Value Engineering Study Report

Georgia Department of Transportation

STP00-2584-00(009) - P.I. No. 142000

**SR 20 from Rosebud Road to Brand Road
Including One Way Pair Gwinnett/Walton Counties**

ALTERNATIVE NO.:
RD-28

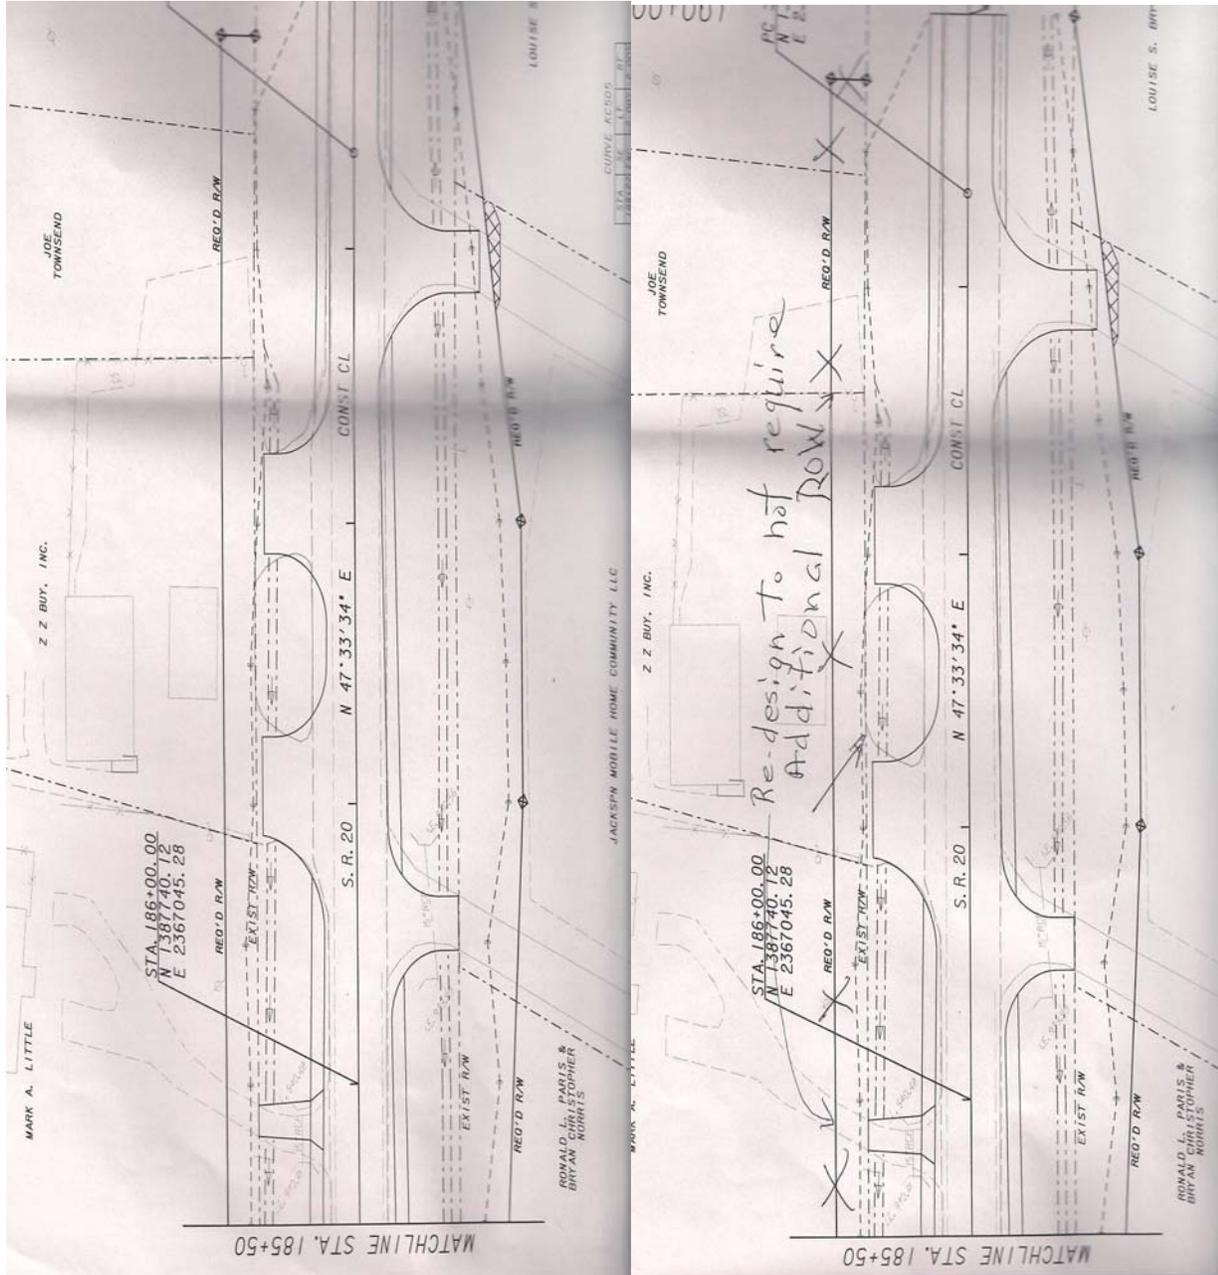
The alternative would be to revise the design as need be to allow the proposed right-of-way line to coincide with the existing property lines; or to acquire a temporary easement for the construction grading.

The current design proposes a 4:1 side slope to create a new surface ditch to route the runoff from the new roadway. It appears reasonable to increase the side slope to 2:1; provide a guard rail and extend the pavement; and move the proposed right-of-way line to coincide with the existing right-of-way lines thereby eliminating the need for a relocation and taking of other private property.
